Submission on the Draft Proposed Layout for Ballydermot Wind Farm

Cllr. Brendan Wyse

September 2021

View from Killina used in Cloncreen Wind Farm Photomontage

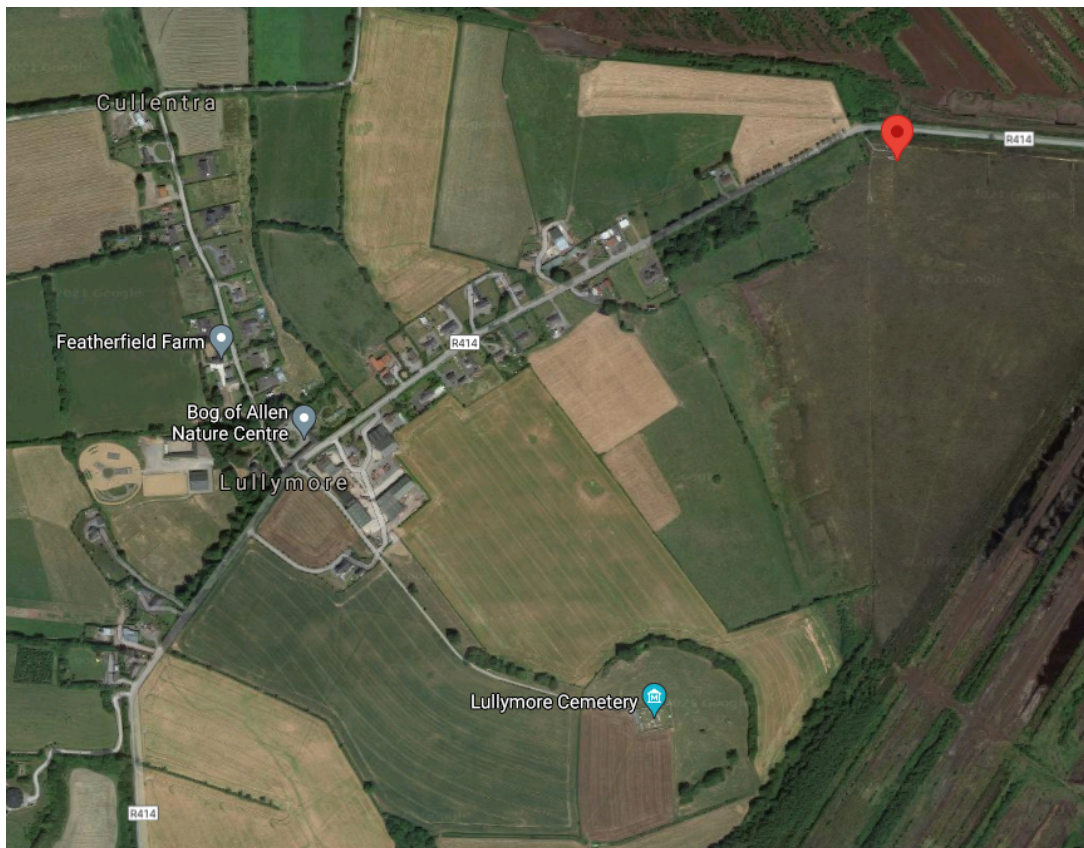
It is noted that the viewpoint at Hamilton's Bridge on the Grand Canal at Killina (as shown below) varies from that used for the same location in the photomontage for the Cloncreen Wind Farm project. The decision to change the viewpoint to one at a lower elevation and where the view is partially restricted by the bridge and raised bank here is questionable.

The viewpoint that was used for the Cloncreen photomontage presents the worst case and most open view of the Ballydermot Wind Farm.

Presenting this alternative, partially restricted view to the local community in your online and printed material does little to encourage a greater sense of local ownership in your project. I am respectfully requesting that the viewpoint be moved to the same location as that used for the Cloncreen Wind Farm (shown below).

Grand Canal Towpath between Ticknevin and Edenderry

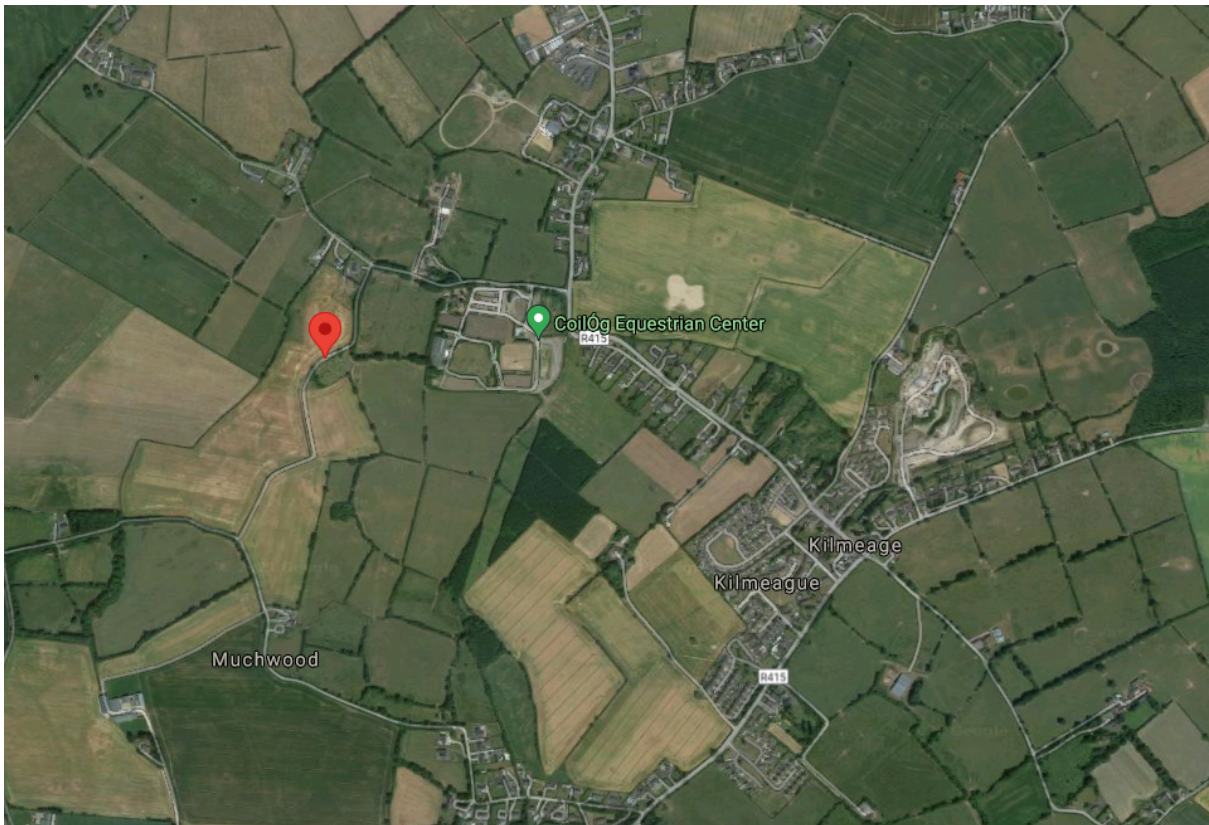
The extent of the towpath on the Grand Canal between Ticknevin and Edenderry, being part of the Grand Canal Greenway, is a popular walking route and one of the very few walking routes in Carbury Parish. The view to the south from the towpath into Ticknevin Bog will no doubt have an impact on this amenity corridor.

In order for that impact to be assessed it is requested that a location on the south bank of the Grand Canal between Ticknevin and Edenderry, with the most open view of the proposed wind farm, be included in the photomontage.

Lullybeg Wetlands

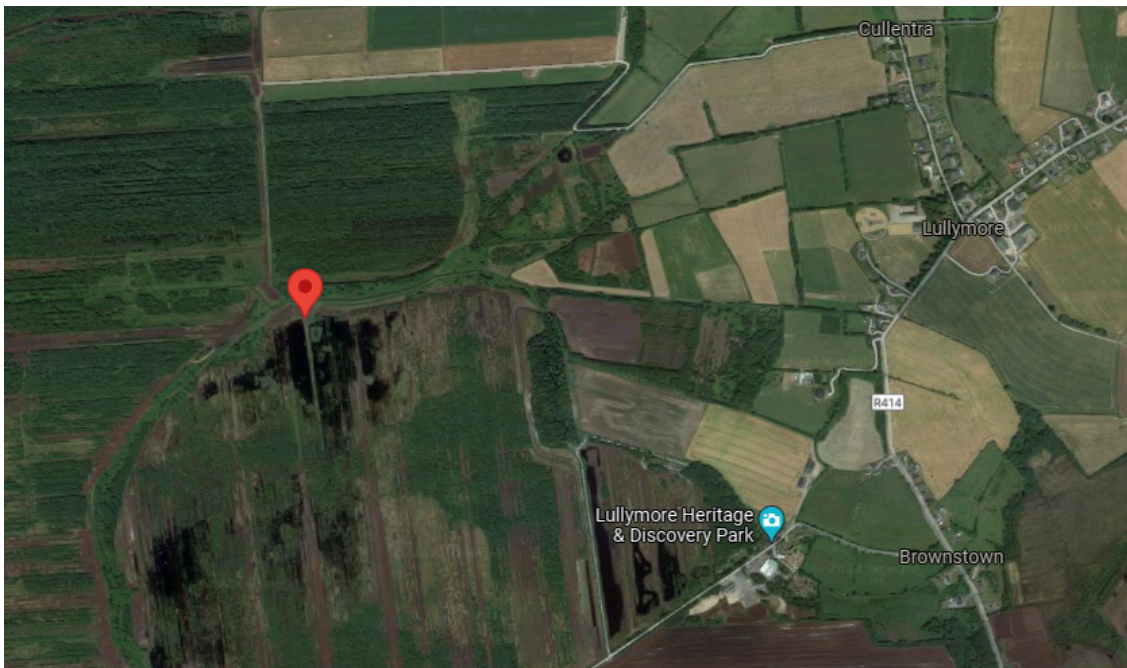
The vast re-wetted area of Lullybeg is already attracting a lot of visitors as it has transformed into a biodiversity hotspot more and more in recent years. Some of the proposed turbines would appear to be very close to the wetlands, and could potentially overshadow the wetlands. This section deals only with the visual impact. The potential impact on biodiversity is described in a later section of this submission.

A regular visiting point is marked on the map below, where there is a short inlet in the lake. It is requested that this inlet be used as a viewpoint in the photomontage.

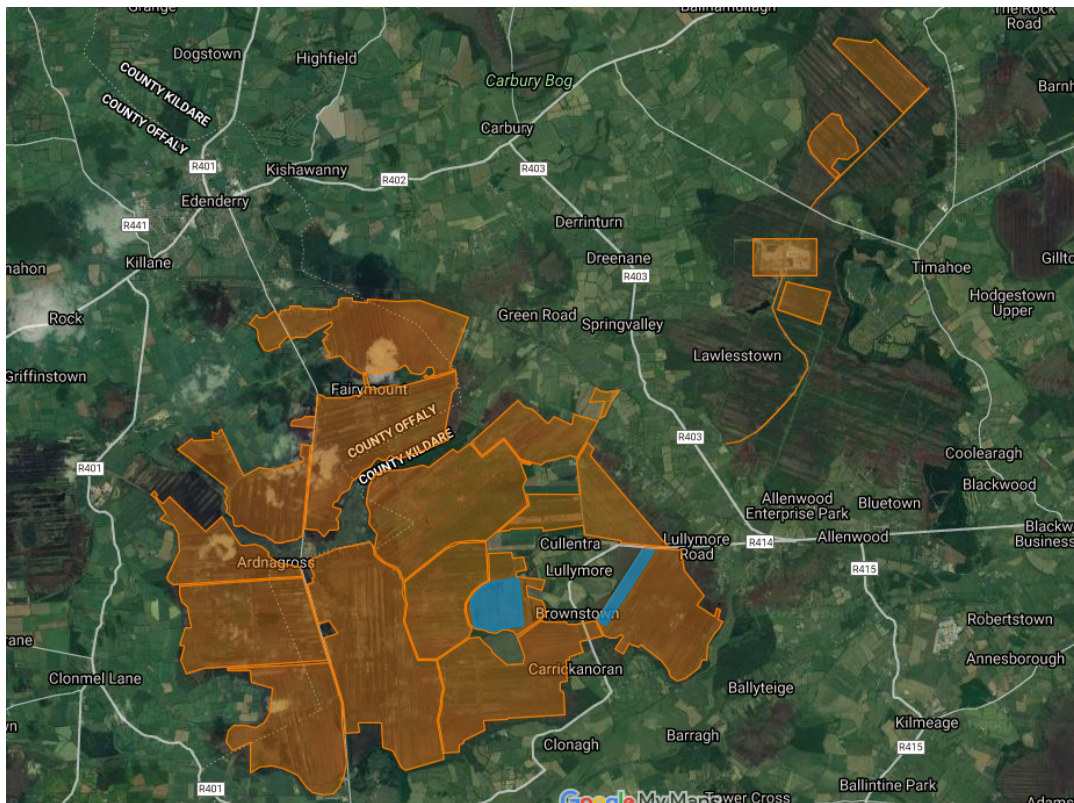
The map above shows marked in light brown, from north-east to south-west, the footprint of the Timahoe North Solar Farm for which planning permission has been granted, the existing Drehid Landfill and the yet to be developed Mechanical Biological Treatment plant adjacent to it and the proposed Ballydermot Wind Farm.

The extreme extent of the area of the proposed wind farm leaves very little room for a sufficient area of West Kildare peatlands to be left for educational, community and amenity use and wilderness corridors such as the proposed National Peatlands Park or the continued rehabilitation of Lodge Bog.

It is my opinion that the project should be scaled back to provide this balance.

Lodge Bog

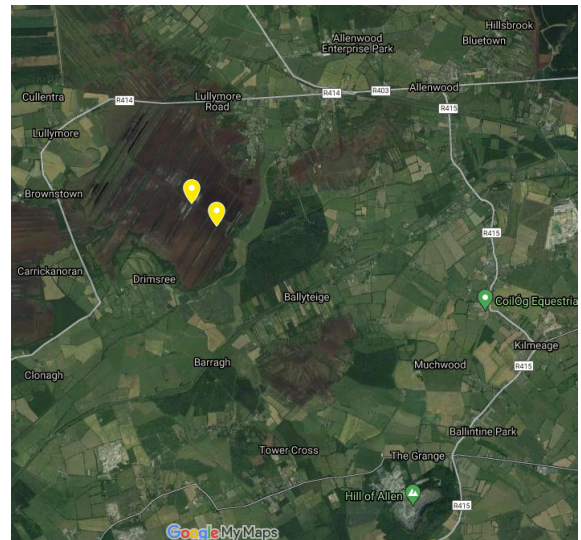
It is impossible to see how the installation of wind turbines on Lodge Bog could be mitigated so as to not have a major negative impact on the landscape and designated scenic route here.

It is recommended to exclude all turbines in Lodge Bog from the final layout and to allow this area to remain for amenity and biodiversity awareness and education. It is acknowledged that a new location for the substation would need to be found also.

Ticknevin Bog

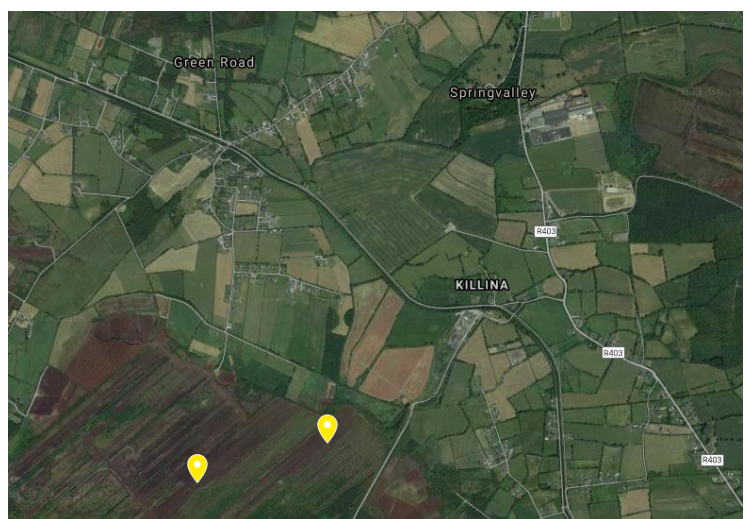
The turbines proposed for Ticknevin Bog will dominate the landscape south of the Grand Canal and the Grand Canal Greenway on the towpath from Ticknevin to Edenderry. This is a landscape where the canal itself is currently the main focus, and should remain so.

The impact of these four turbines, and in particular the two most northern turbines, will need to be clearly identified and presented before finalising the project planning application. It is difficult to see, however, how the inclusion of all four of these turbines will not have a significant impact on the Grand Canal amenity corridor.

Lullybeg Wetlands

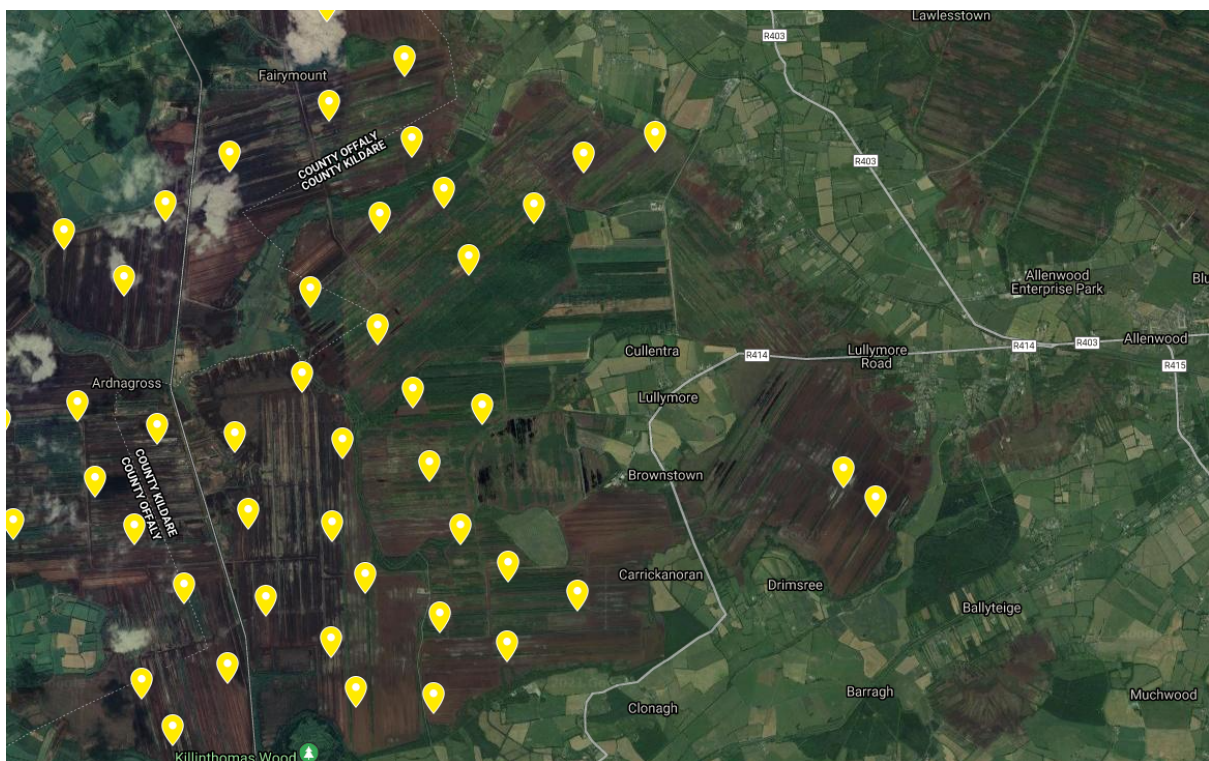
There are four turbines in close proximity to the lake, and I ask the project team to engage with, and listen, to groups such as the Irish Peatland Conservation Council, Butterfly Conservation Ireland and Birdwatch Ireland Kildare Branch regarding the impact these turbines could have on the biodiversity in the Lullybeg Wetlands area.
